Southern Nuclear Operating Company  
Vogtle Electric Generating Plant Units 3 and 4  
Revised Request for License Amendment:  
Containment Internal Floor Module Connections (LAR-15-012 R2)

**Vogtle Electric Generating Plant (VEGP) Units 3 and 4**

**Revised Request for License Amendment:**

**Revised Proposed Changes to Licensing Basis Documents  
(LAR-15-012 R2)**

**UFSAR Section 3.8, Figure 3.8.3-3, Structural Floor Module - Revise information for the structural floor module as shown below.**

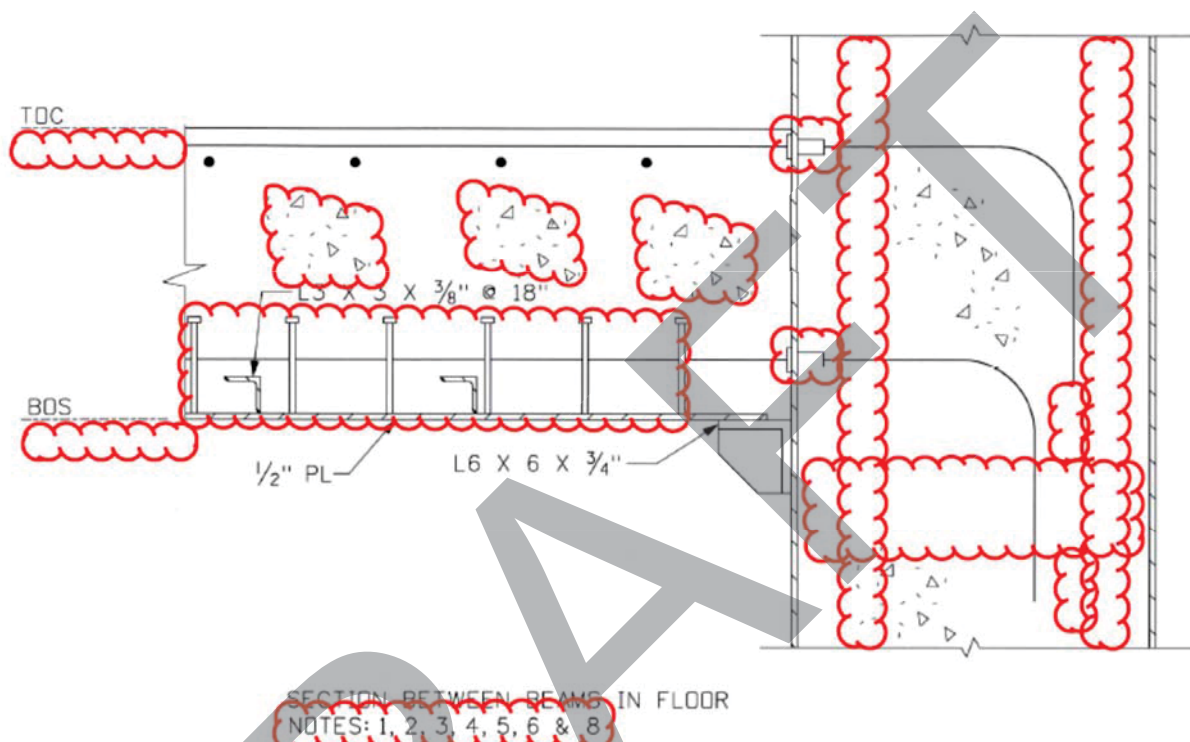
UFSAR Figure 3.8.3-3 shows the floor module design and is revised to include the shear studs attached on top of the bottom steel plate of the floor module. (These shear studs are also appropriately added to revised Figure 3.8.3-17, Sheets 1 and 3.) Notes are added to the figure to identify variation in the floor design elements including reinforcement, to provide the range of reinforcement sizes used, and to reference the use of wide flange beams and channels. The figure is also revised to remove the elevations for top of concrete (TOC). A note is added about the welding requirements.

- E. Revise UFSAR Figure 3.8.3-3 to add shear studs on top of the bottom steel plate of the floor module, to add notes to identify variation in the floor design elements including reinforcement, to provide the range of reinforcement sizes used, and to reference the use of wide flange beams and channels. Additionally, elevations for top of concrete (TOC) are removed and a note is added about the welding requirements.

Provide a corrected Note 4 for UFSAR Figure 3.8.3-3. Note 4 is currently showing an extra period (AWS D.1.1 vs AWS D1.1) in the code listing.

Note 4 for revised UFSAR Figure 3.8.3-3 is revised to correct the identified reference to the AWS code as shown in the markups below (see page 8 of 8).

**UFSAR Section 3.8, Figure 3.8.3-17, Sheet 1 of 2 [Structural Modules –Design Details  
Standard Floor Connection]\* - Revise information for the SECTION BETWEEN BEAMS IN  
FLOOR as shown below.**

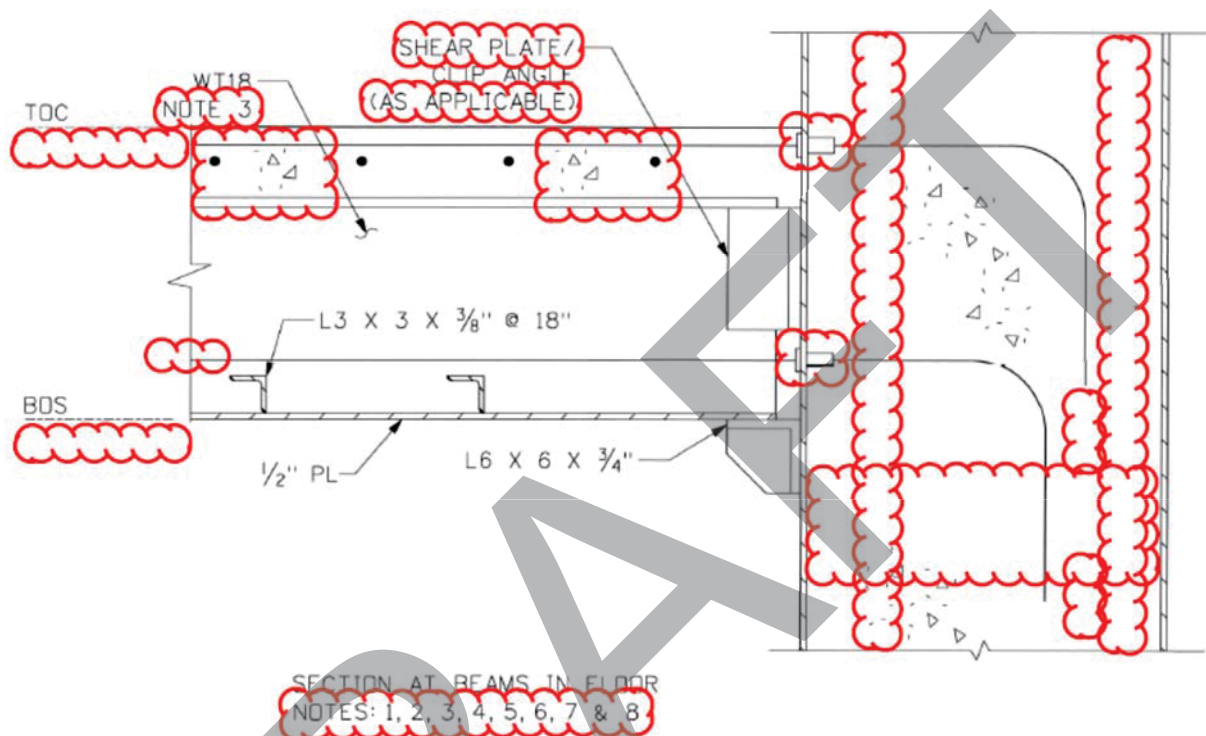
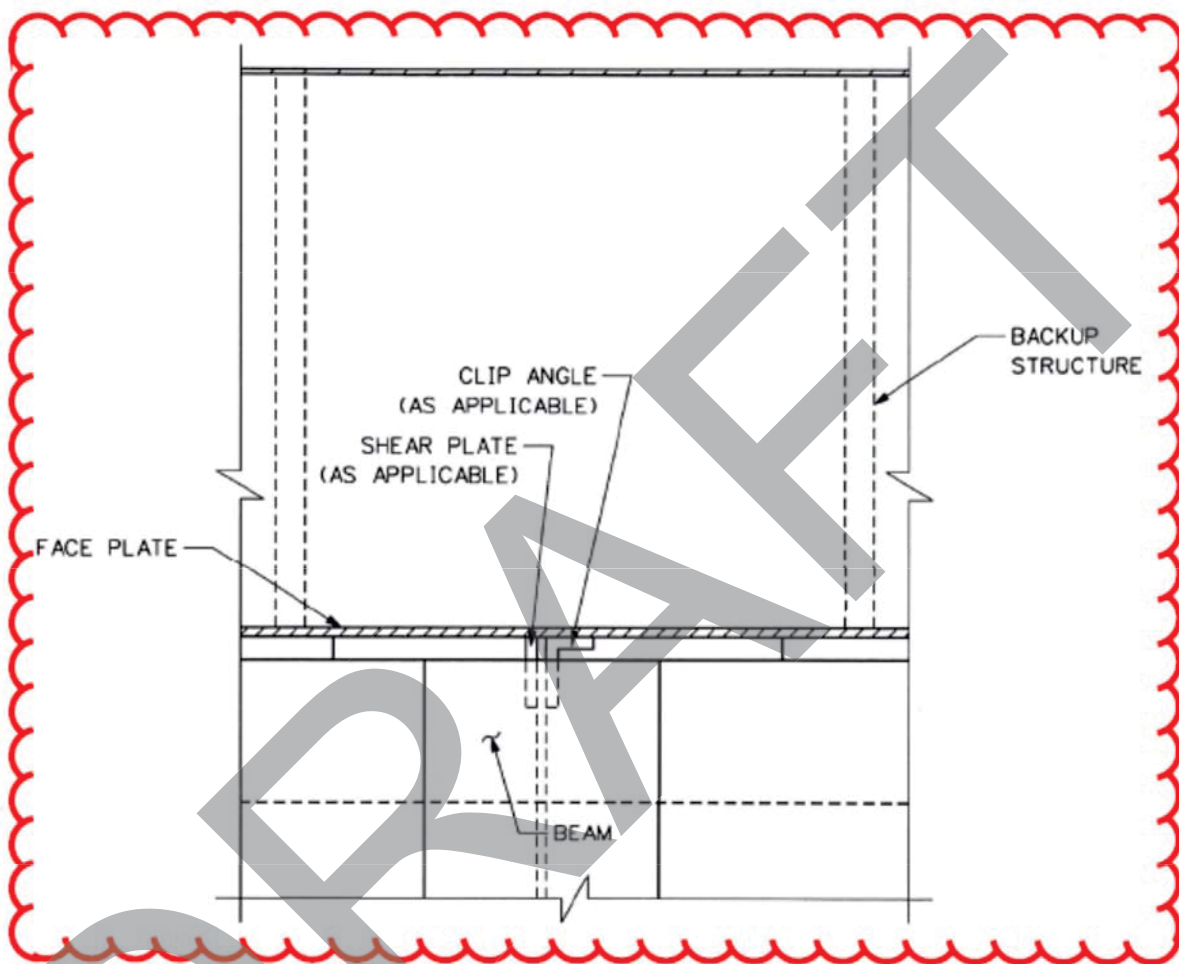
- F. Revise the information in UFSAR Figure 3.8.3-17, Sheets 1 and 2, "Structural Modules – Design Details Standard Floor Connection" and "Structural Modules – Design Details Heavily Loaded Floor Connection" respectively, for clarity as follows:

5. Redraw reinforcement hooks to show proper length for standard hooks in both sections on Sheet 1 and in SECTION BETWEEN BEAMS IN FLOOR on Sheet 2.

6. Change representation of reinforcement connector on faceplate to show representative configuration of the connector in both sections on Sheet 1.
7. Remove the dimensions from the wall module internal structure and from the plate thickness of backup structure from Top View on Sheet 2.

11. Remove the elevations for TOC (top of concrete) and BOS (bottom of steel) on Sheet 1 and Sheet 2.
12. Move arrows identifying Section A in SECTION AT BEAMS IN FLOOR on Sheet 2 to clarify the location of Section A.

13. Remove symbols indicating concrete from Sheet 2 SECTION AT BEAMS IN FLOOR and add the symbols indicating concrete to Sheet 2 SECTION BETWEEN BEAMS IN FLOOR and Sheet 1 SECTION BETWEEN BEAMS IN FLOOR to be consistent with the materials at those locations.

16. Add designation of reinforcement bar size (#11) to Sheet 2 SECTION BETWEEN BEAMS IN FLOOR.
17. Add shear studs attached on top of the bottom steel plate of the floor module in SECTION BETWEEN BEAMS IN FLOOR in Sheet 1 and 2.

1. DETAILS SHOWN ARE REPRESENTATIVE OF FLOOR MODULES AT EL 107'-2" AND 135'-3" AND THE CONNECTIONS OF FLOOR MODULES TO WALL MODULES INSIDE CONTAINMENT. REFER TO SUBSECTION 3.8.3.1.3 AND OTHER NOTES FOR ADDITIONAL INFORMATION ABOUT DESIGN DETAILS AND VARIATIONS FOR FLOOR MODULE TO WALL MODULE CONNECTIONS. DETAILS ARE NOT REPRESENTATIVE OF THE CONNECTION BETWEEN THE OPERATING DECK FLOOR AND THE WALL MODULES THAT FORM THE SIDES OF THE REFUELING CANAL; SEE SUBSECTION 3.8.3.5.8.1.

2. REINFORCEMENT USE, SIZE, AND SPACING IN THE FLOOR MODULE CONCRETE SATISFY THE REQUIREMENTS IN ACI 349. THE REINFORCEMENT SIZE RANGE IS #7 TO #11.
3. DESIGN OF THE PLATES, BEAMS, AND STIFFENERS IN THE FLOOR, INCLUDING PLATE SIZE AND SPACING, AND TYPE, SIZE, AND SPACING OF STRUCTURAL SHAPES VARIES AND SATISFIES THE REQUIREMENTS OF AISC N690.

**UFSAR Section 3.8, Figure 3.8.3-17, Sheet 2 of 2 [Structural Modules –Design Details Heavily Loaded Floor Connection]\* - Revise information for the TOP VIEW AT BEAMS IN FLOOR as shown below.**

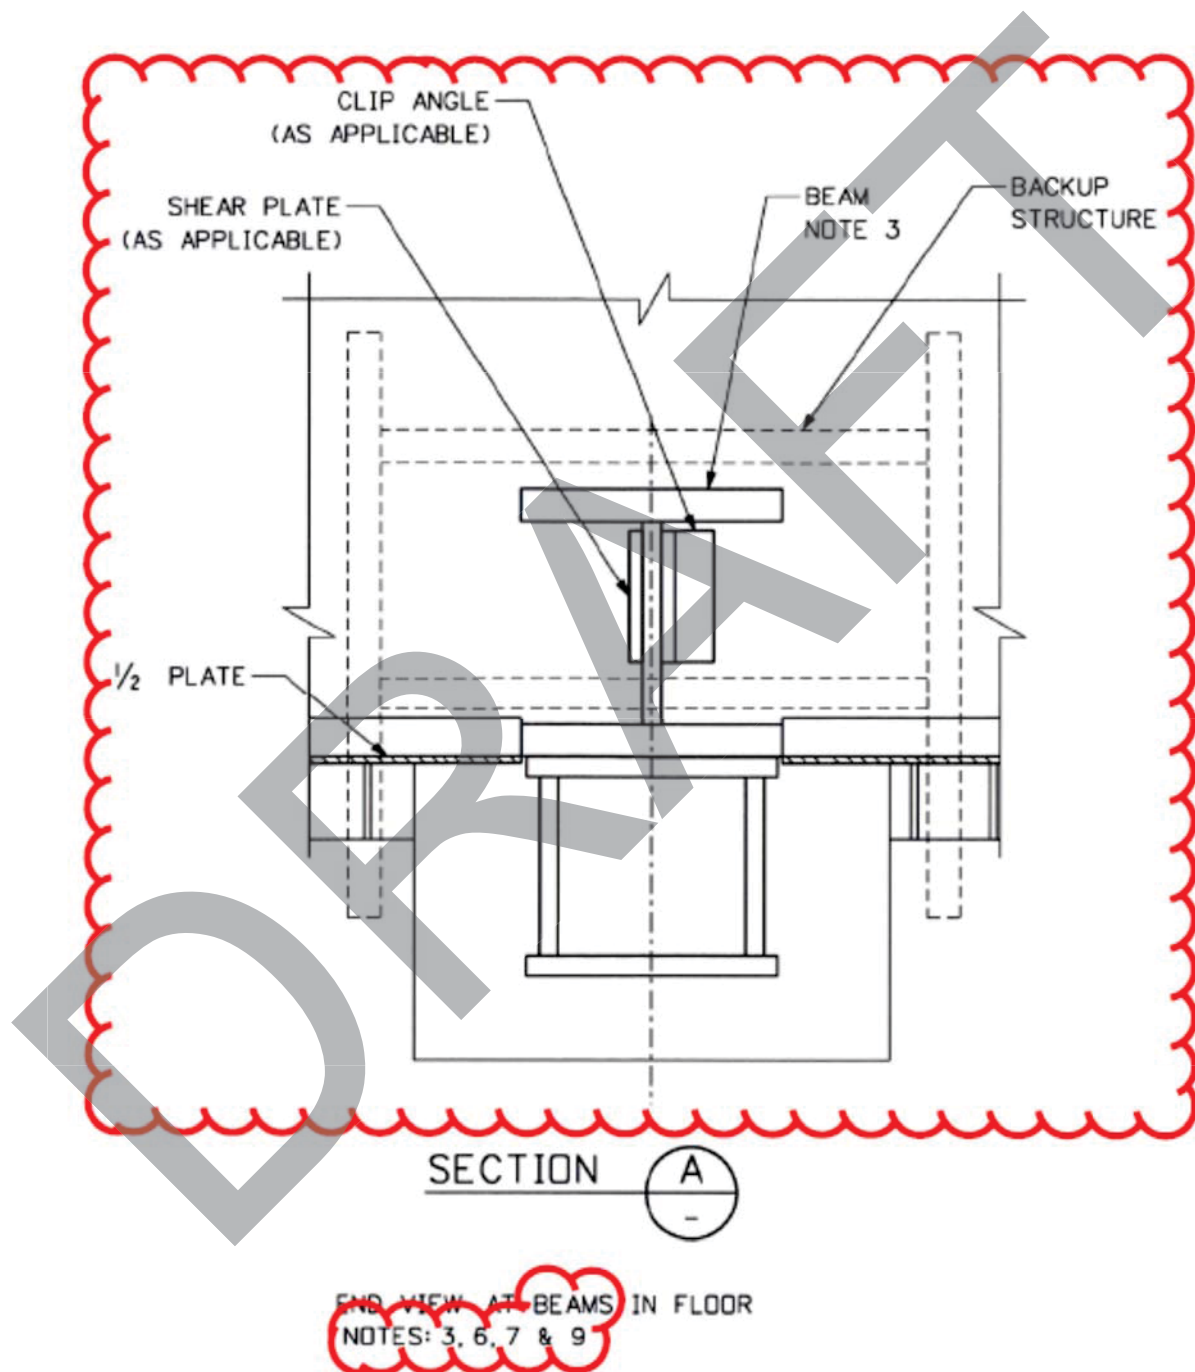
3. Add "SHEAR PLATE" and the term "(AS APPLICABLE)" to the clip angle designation where shown on Sheet 1 and Sheet 2. Revise the figure to show a clip angle and a shear plate instead of two clip angles in the connection in Sheet 2, TOP VIEW AT BEAMS IN FLOOR and in Section A.

4. Redraw Section A and "TOP VIEW AT BEAMS IN FLOOR" on Sheet 2 to show connection design based on design finalization. The changes remove the reinforcement adjacent to the beam section and remove the connectors adjacent to the beam in Section A.

8. Redraw the representation of the backup structure in Top View, SECTION AT BEAMS IN FLOOR, and Section A on Sheet 2.
9. Redraw the representation of the wall module structure on Sheet 2 to move and reconfigure the plates applied or overlaid onto the faceplates on the connection side of the wall module in TOP VIEW AT BEAMS IN FLOOR, SECTION AT BEAMS IN FLOOR and SECTION BETWEEN BEAMS IN FLOOR.

10. Remove the reinforcement bars in the floor and the reinforcement connectors in the Top View, Section A, and in the SECTION AT BEAMS IN FLOOR on Sheet 2.

**UFSAR Section 3.8, Figure 3.8.3-17, Sheet 2 of 2 [Structural Modules – Design Details Heavily Loaded Floor Connection]\* - Revise information for the SECTION AT BEAMS IN FLOOR as shown below.**

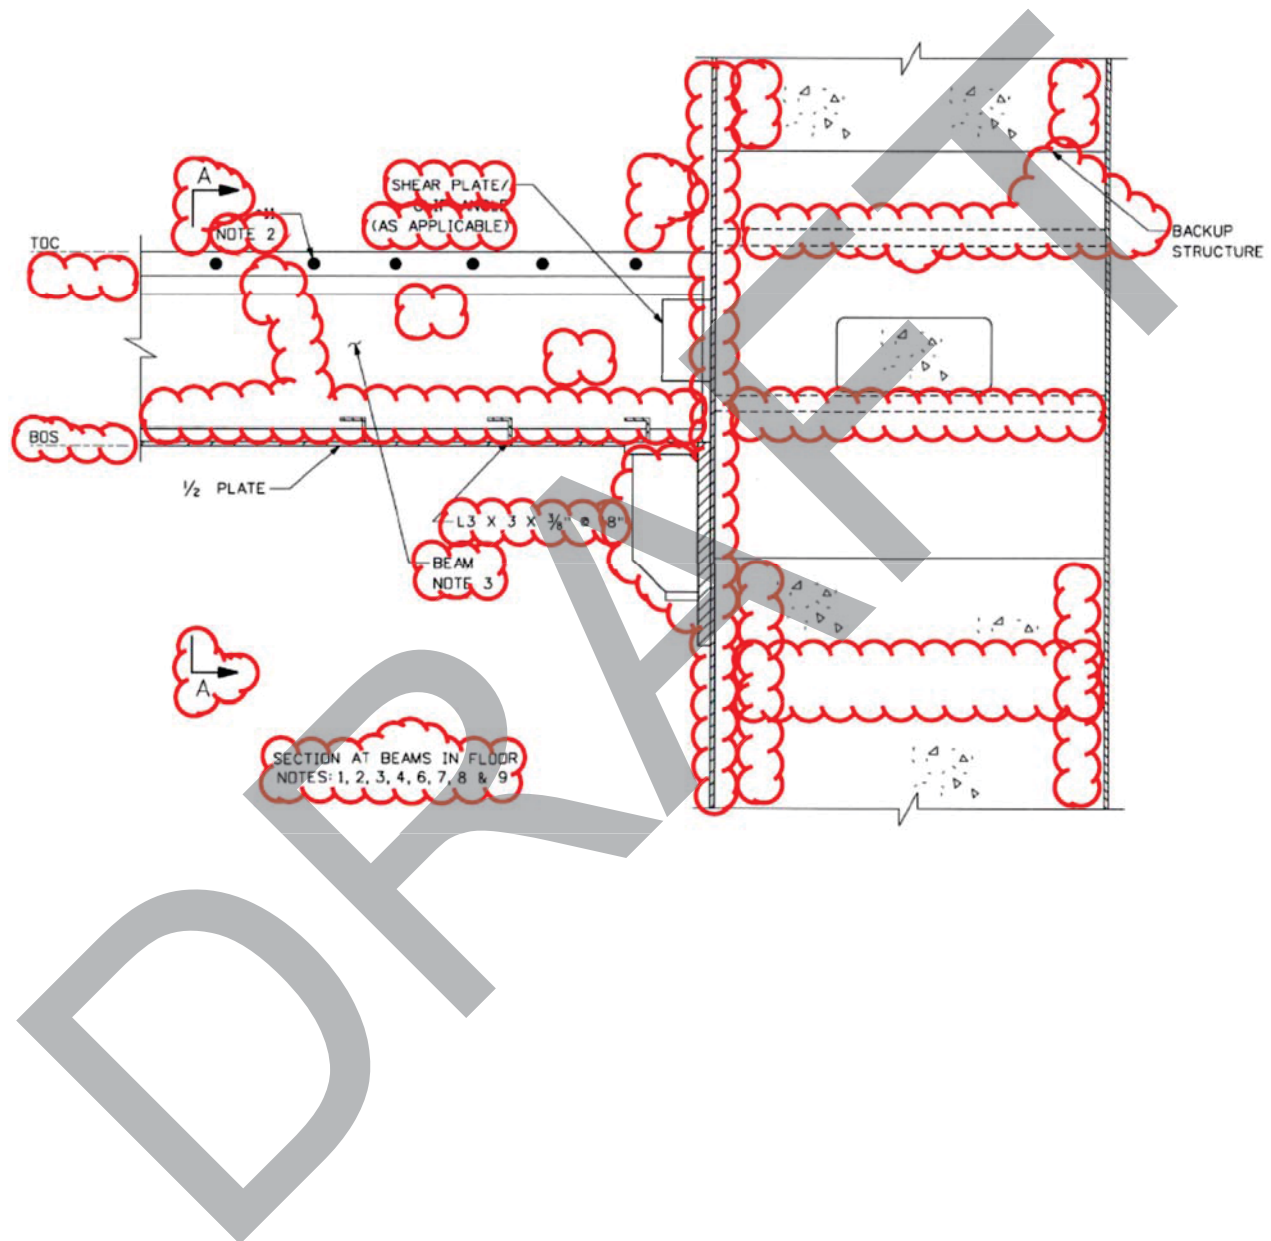
14. Add the dimensions for the angles welded to the floor in Sheet 2, SECTION AT BEAMS IN FLOOR.
15. Replace the seat angle with a beam seat in Sheet 2, SECTION AT BEAMS IN FLOOR.

8. THE THICKNESS OF THE ADJACENT WALL IS BASED ON THE WALL DESIGN REQUIREMENTS AND LOCATION.
9. THE BEAM SEAT SHOWN IS NOT USED AT ALL BEAM LOCATIONS. THE SEAT ANGLE SHOWN ON SHEET 1 IS USED AT OTHER LOCATIONS.

**Figure 2: Elevation View of CA37 Floor to CA01 Wall Connection**

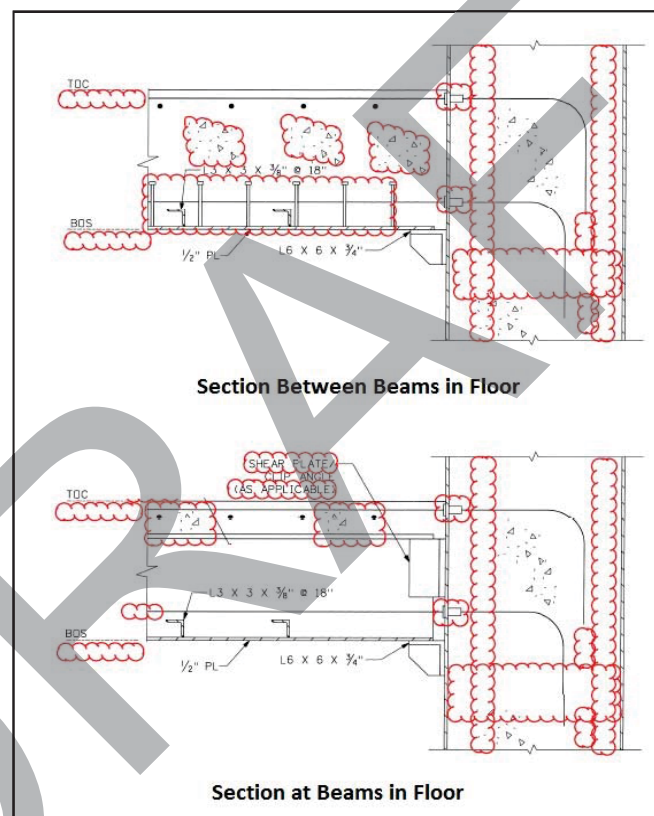
Figure 2 (revised UFSAR Figure 3.8.3-17 (Sheet 1 of 2) as proposed in SNC LAR-15-012R1 and shown below) shows the configuration of the CA37 module floor-to-CA01 wall connection (Area 4 in Containment, top of floor elevation 107'-2"). This connection is composed primarily of encased steel beams that are welded to continuous stiffened angle beam seats. The seats are continuously welded to the CA01 module wall faceplate. Additionally, there are top and bottom dowels that connect the CA37 floor to the CA01 wall. At some locations where the encased beams are heavier to carry heavier loads, such as the Core Makeup Tank, there are heavy beam seats instead of the continuous stiffened angle. These heavy beam seats are referred to as beam pedestals.

Table 1 describes the interaction ratios for the CA37 module floor to CA01 module wall connection (Area 4 in Containment, top of floor elevation 107'-2").

Table 1 includes results that envelope locations along wall CA01, which include beam connections with clip angles and no back-up structures as shown in UFSAR Figure 3.8.3-17, Sheet 1, "Structural Modules - Design Details Standard Floor Connection," connections with clip angles and back-up structures as shown in UFSAR Figure 3.8.3-17, Sheet 2, "Structural Modules - Design Details Heavily Loaded Floor Connections," and connections in between beams that show only top and bottom rebar, as shown in both UFSAR Figure 3.8.3-17, Sheets 1 and 2.
